HIDALGO COUNTY COURTHOUSE REVIEW

FINAL REPORT / MARCH 24, 2015

PEER REVIEW REPORT

Current Design Vehicular Sallyport Illustration

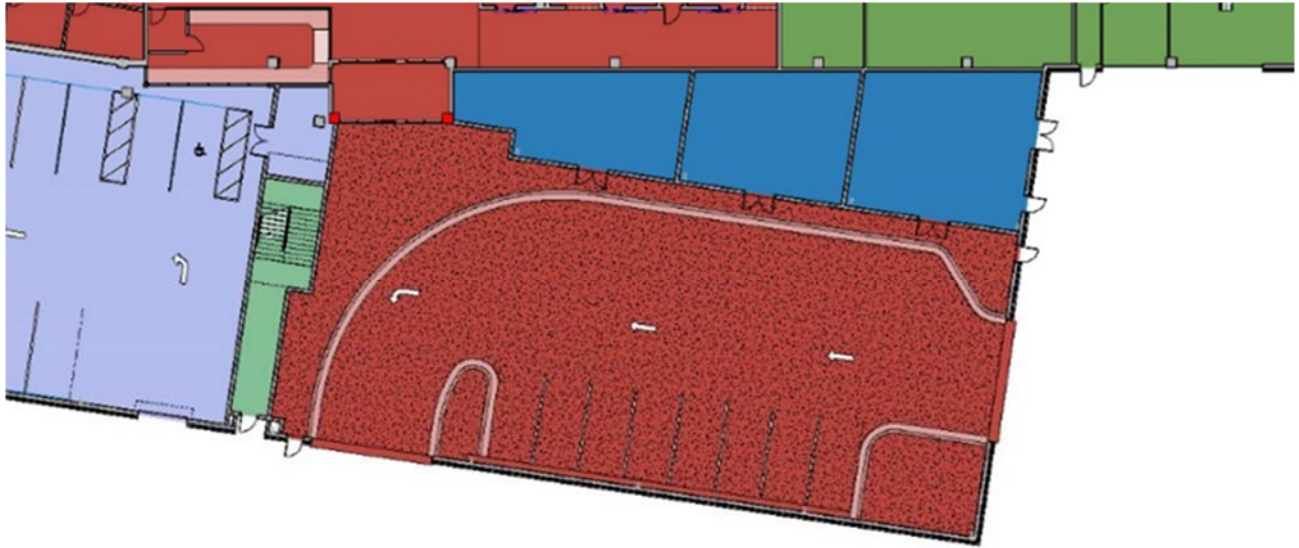
- The space program shows a 1,500 sf vehicle sallyport
- The drawing shows a vehicle sallyport sized at about 8,500 sf.
- Due to the significant increase in size from the space program, the intent of the vehicle sallyport needs to be discussed to determine an appropriate size
- Additionally, opening mechanical equipment spaces to the vehicle sallyport can be a security issue when routine maintenance needs to be performed and inmates are being delivered to the building

Current Design Central Inmate Holding Area Illustration

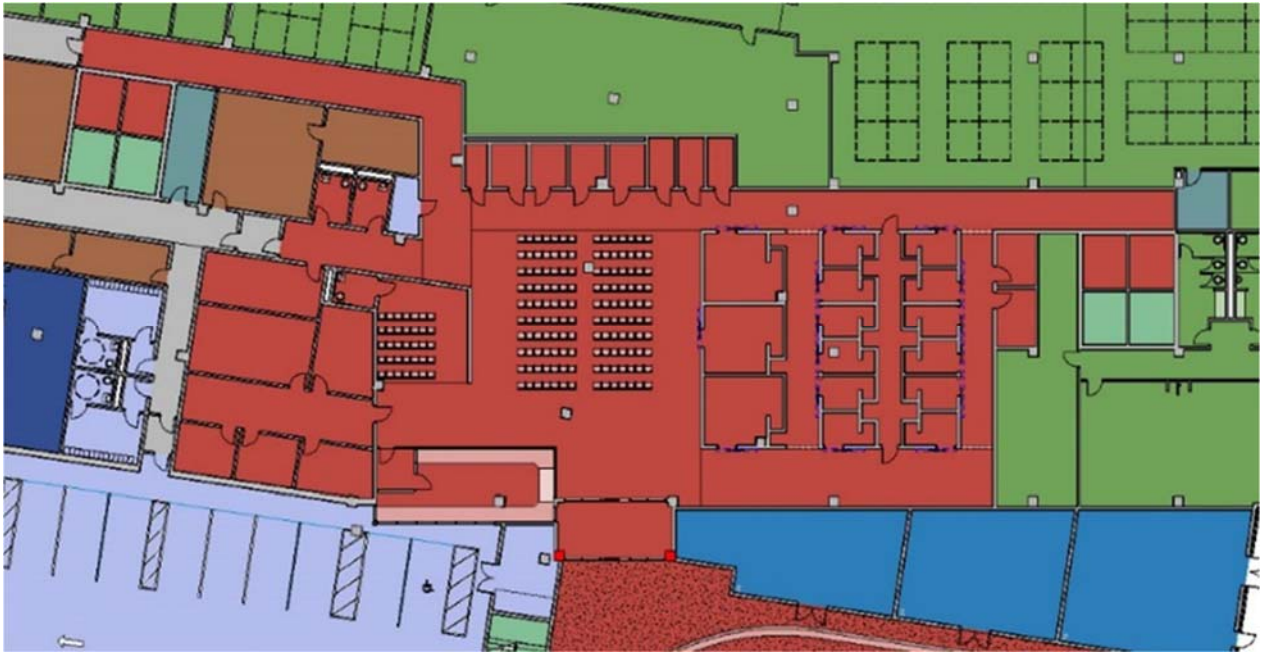
- Central Inmate Holding Area shown in red with space for 223 inmates
- Managing 175 multi-classified inmates in an open seating area is not common. This needs to be discussed in more detail with Sheriff Dept. This is expensive to build and operate.
- Additionally, each Courtroom has a group holding cell plus a single holding cell. Space for 312 inmates
- **Total Holding capacity at the courthouse = 535 inmates**

Current Design Typical Courtroom Holding Illustration

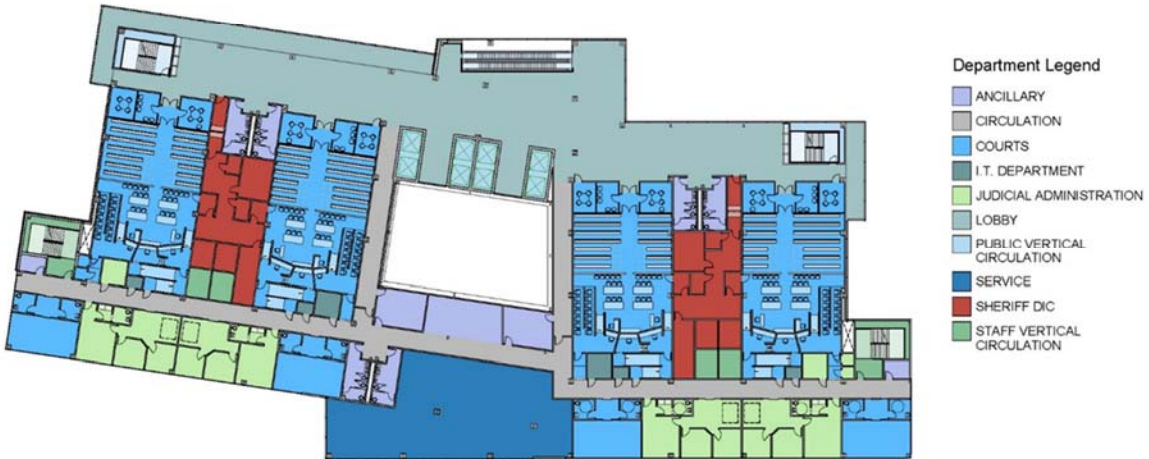
- Program shows 1 single holding cell per court.
- Drawings show a single and a group holding cell for each court
- 1 Inmate Elevator for each courtroom, twice the number typically seen
- We need to discuss with the Sheriff Department how inmates will be managed and moved through the building
- **Fewer than 200 inmates are delivered to the Courthouse each day**

Current Design Typical Courtroom Floor Illustration

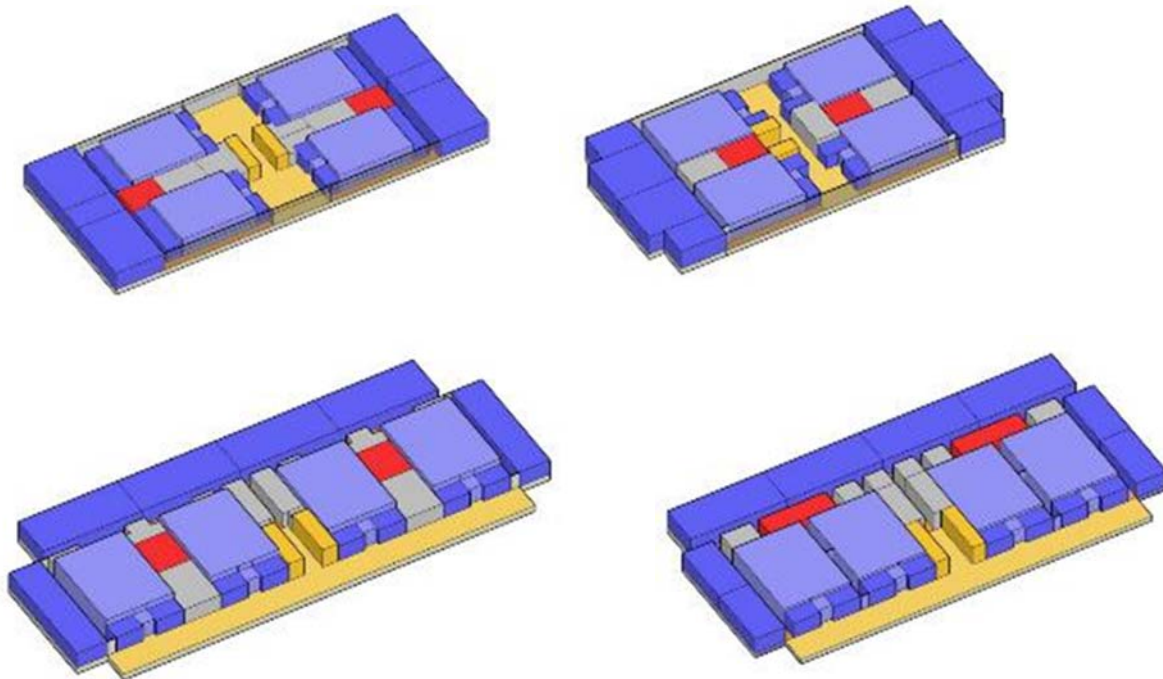
- Typical floor plans of 4 courts per floor for a similar Texas project (average approx. 38,000 sf per floor)
- Current Hidalgo County SD plan of 4 courts per floor (Approx. 43,400 sf per floor)

Illustration of 6 Courts per floor in the same footprint as 4 court per floor

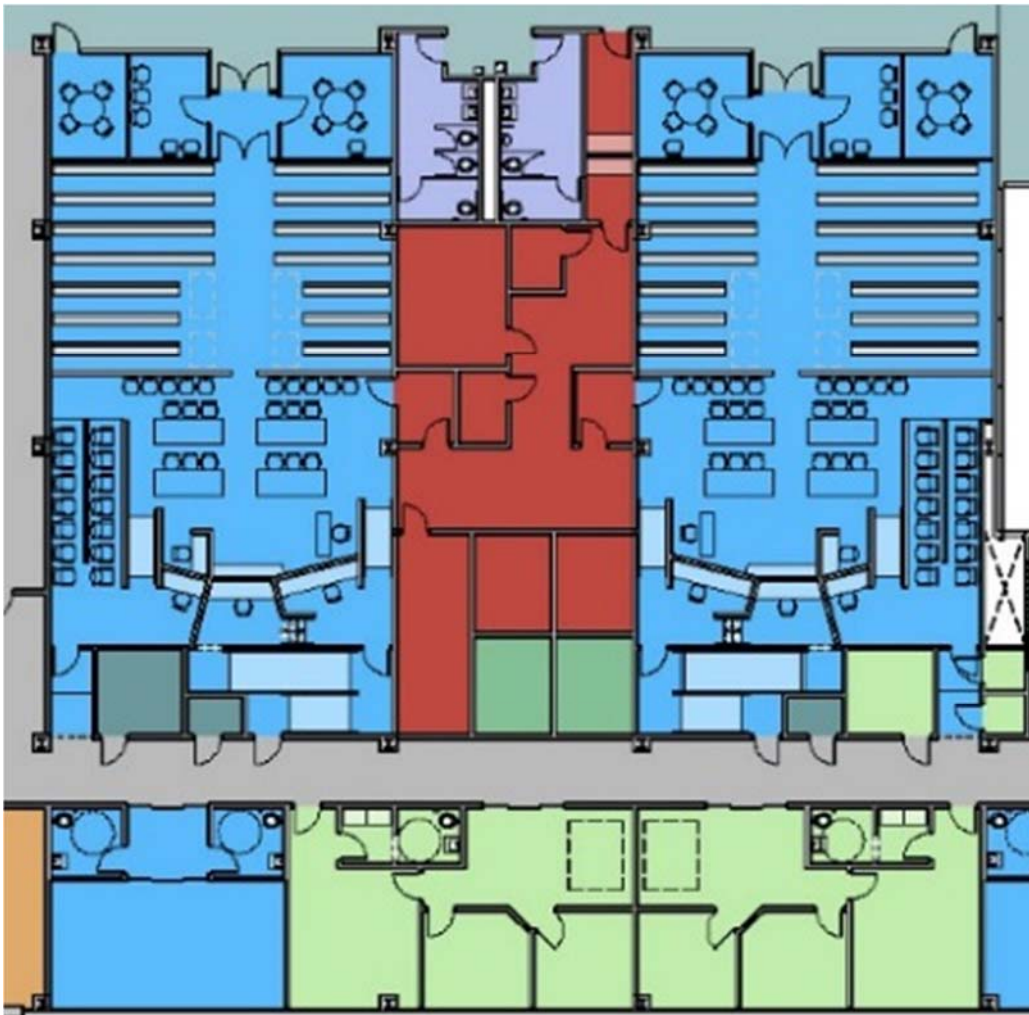
- 6 Courthouse Floors x difference of 5,400 sf per floor = 32,000 sf, which equates to \$11,858,400 of savings

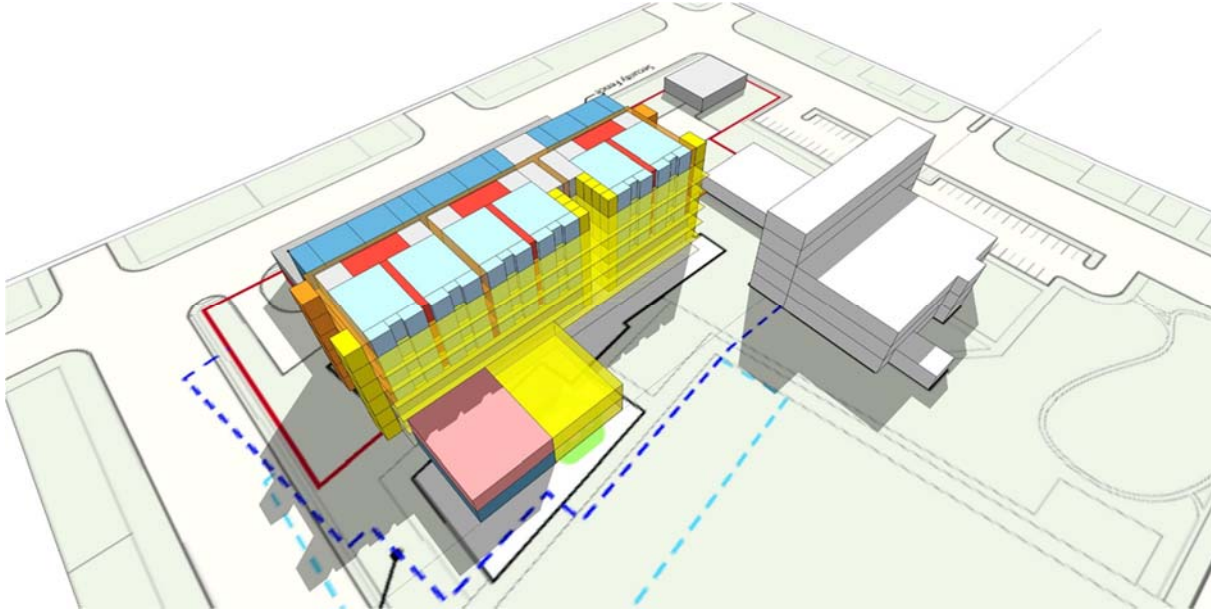
- 6 Story Building, 6 courts per floor
- 2 Podium floors
- Smaller footprint than the Current Design
